RECEIPT DATE: 2-8-18 **ONSITE SEWAGE DISPOSAL SYSTEM** P 562422

PROPERTY ADDRESS: 1015 Fairlane Road

SUBDIVISION: Fairlane Farms LOT: 16 TAX ID: _____

SEPTIC SYSTEM
 INSTALLATION SITE PLAN
 LOT 16
 1015 FAIRLANE ROAD
 FAIRLANE FARMS
 PHASE ONE
 ZONED: RC-DEO

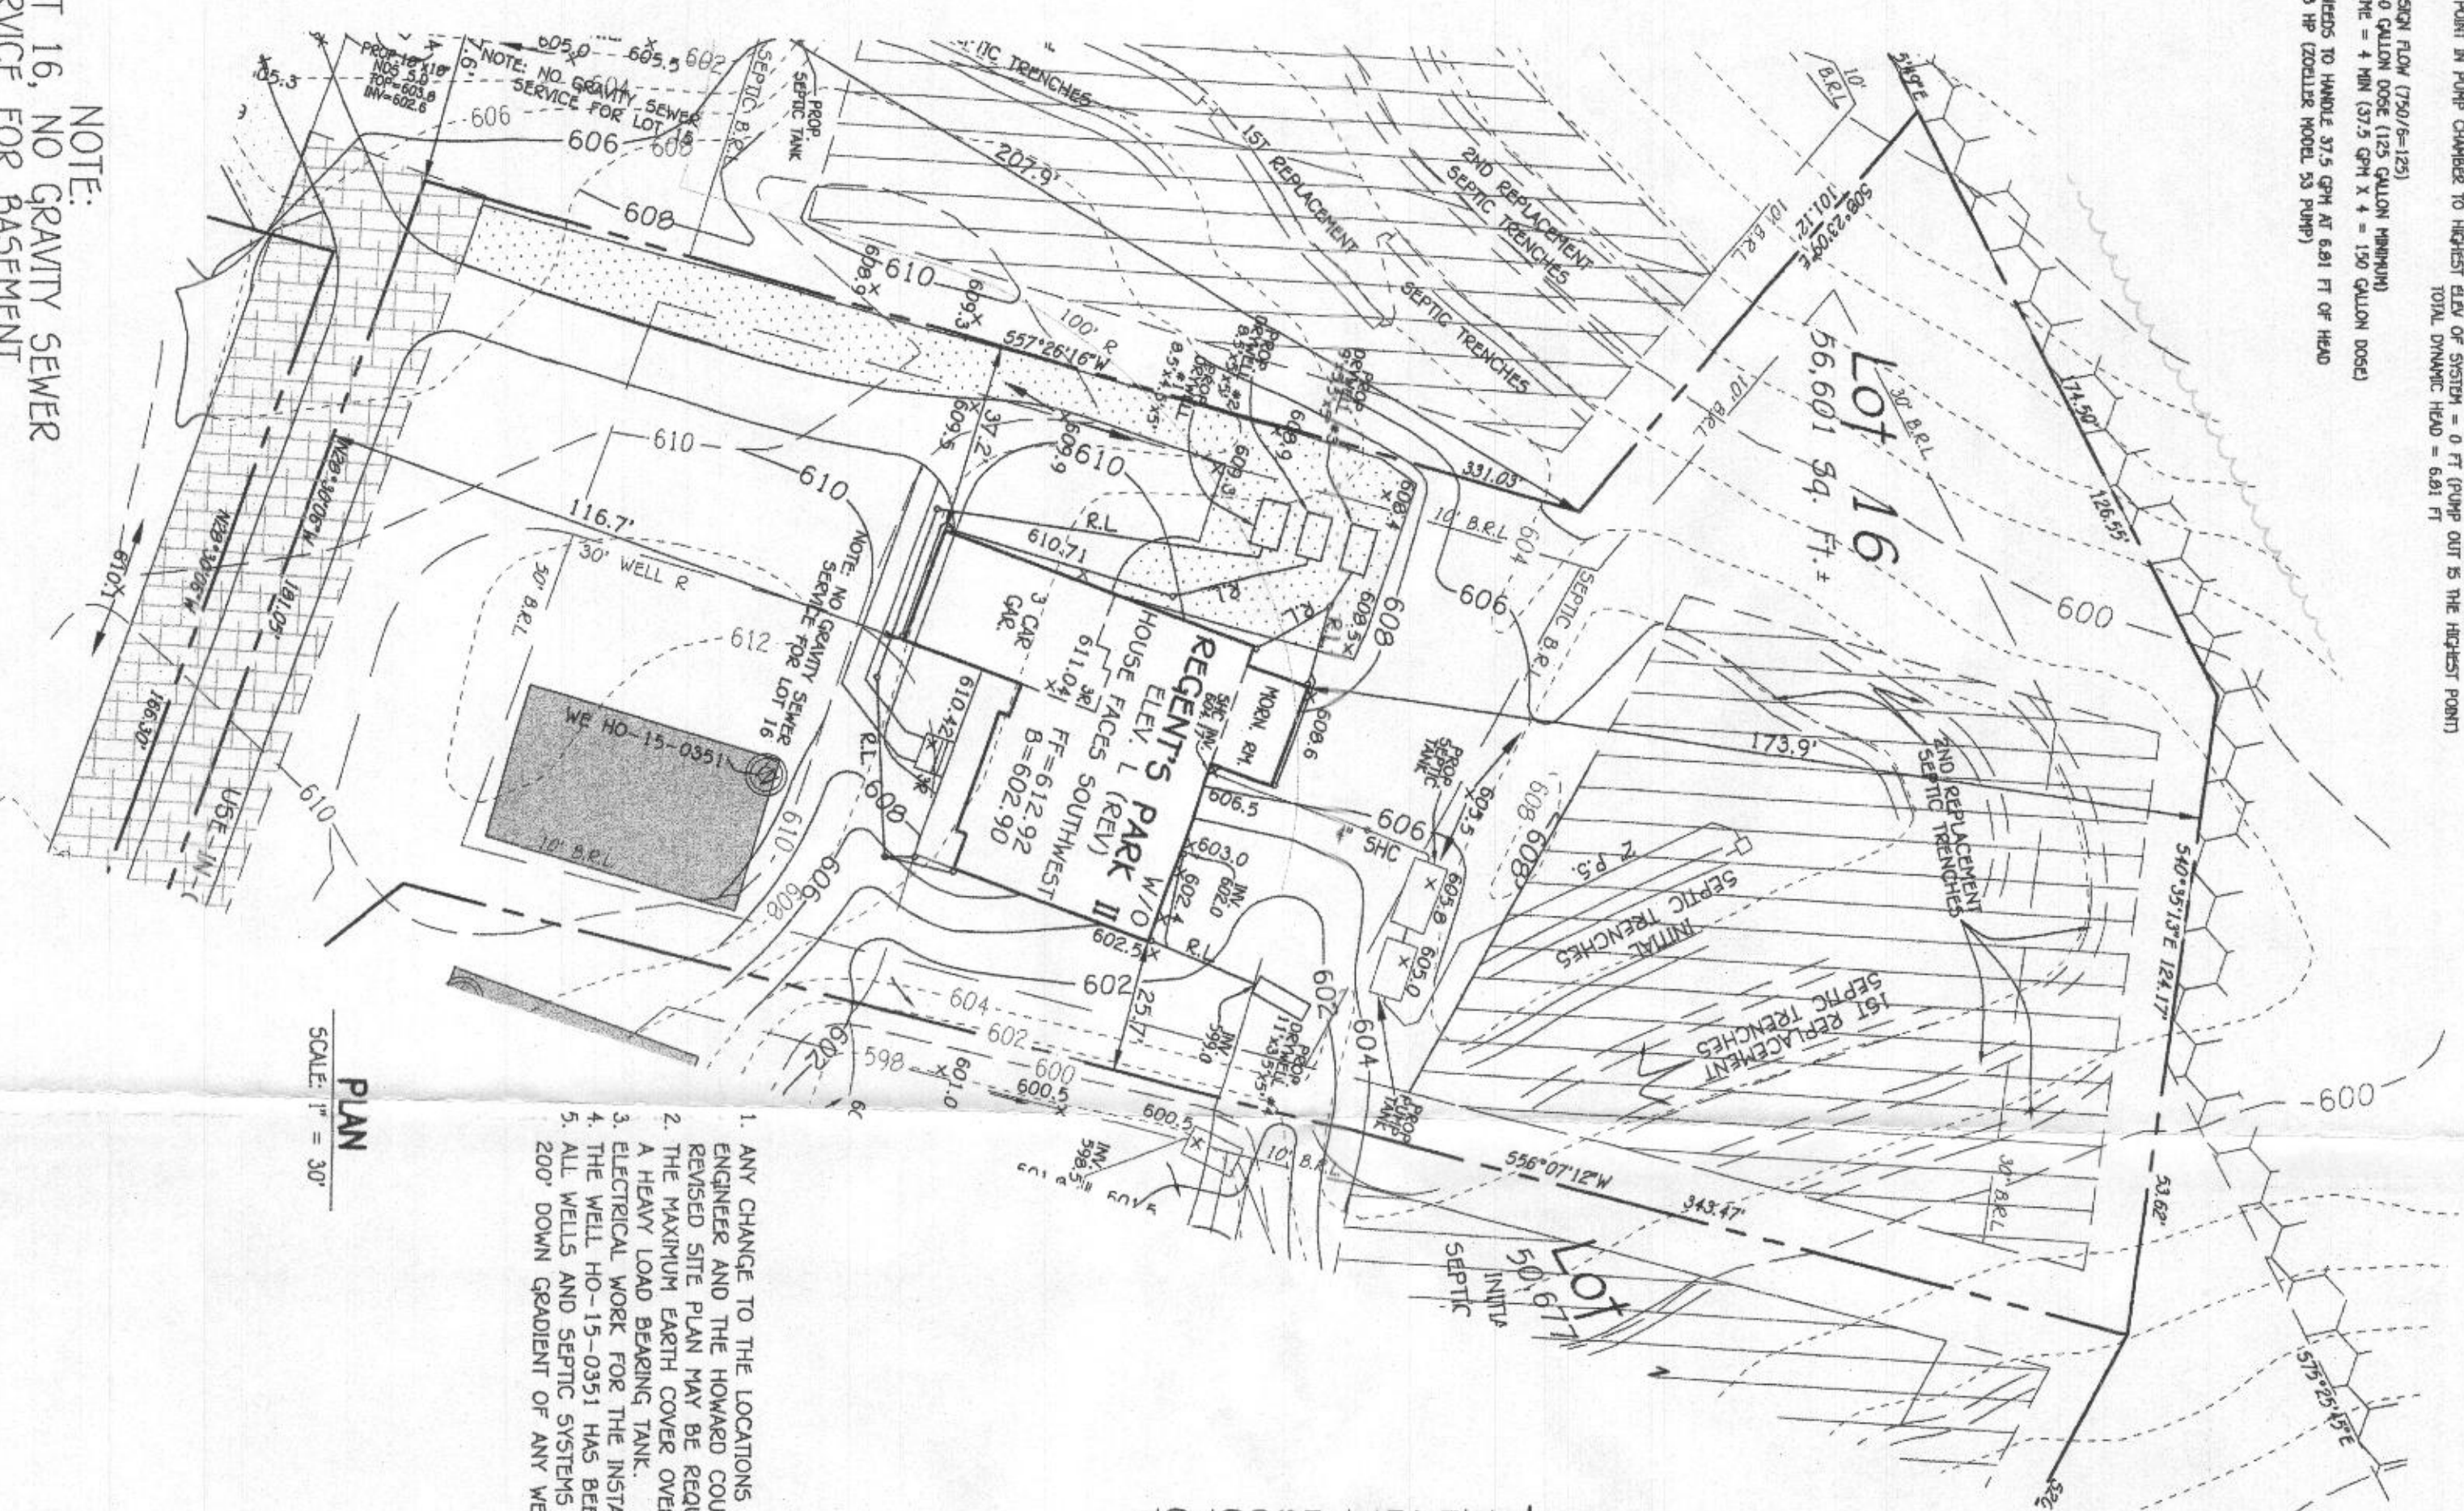
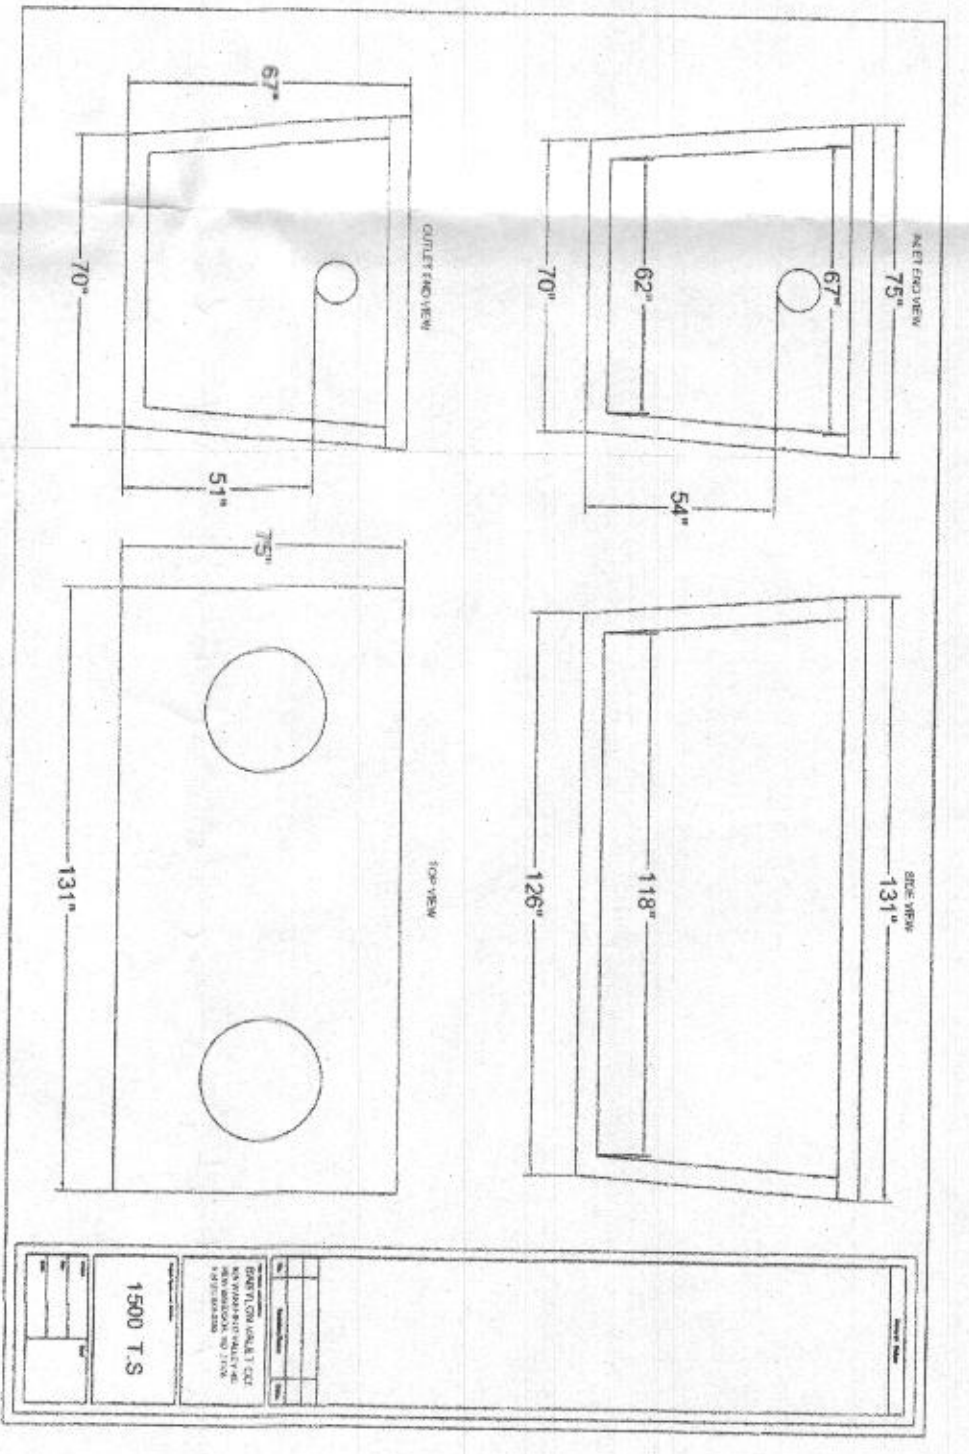
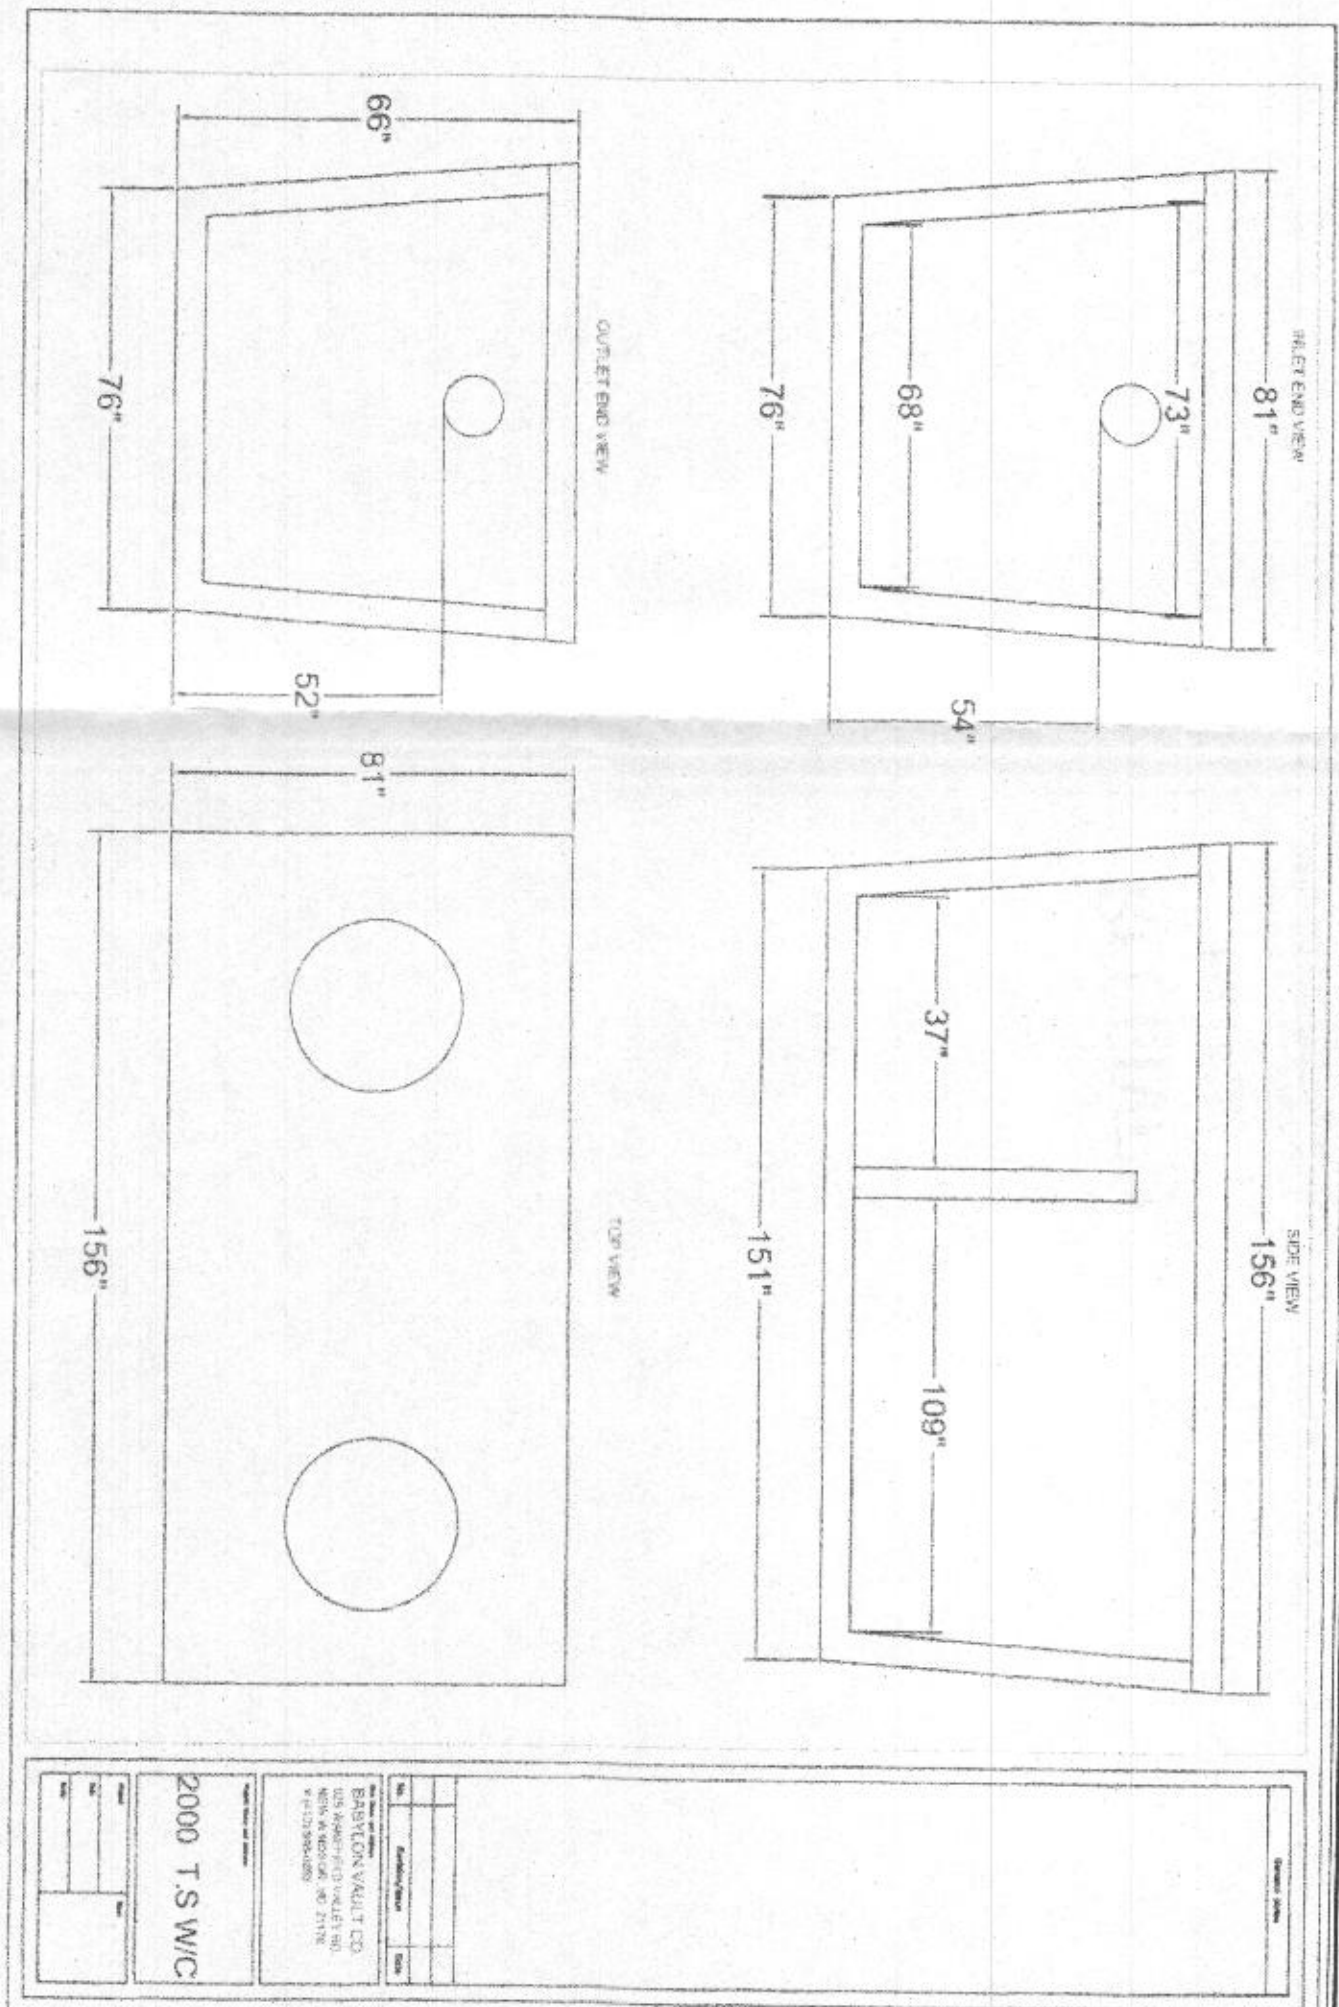
The inverts are still not lining up. Also, the coefficient of reduction calculation for the 2nd replacement system is incorrect. There is no point in showing the calculation because there is no sidewall credit to be given toward the 2nd system (It doesn't equate to 1).

Can you please look over the plan and revise it or let me know what the inverts are supposed to be and I can redline it.
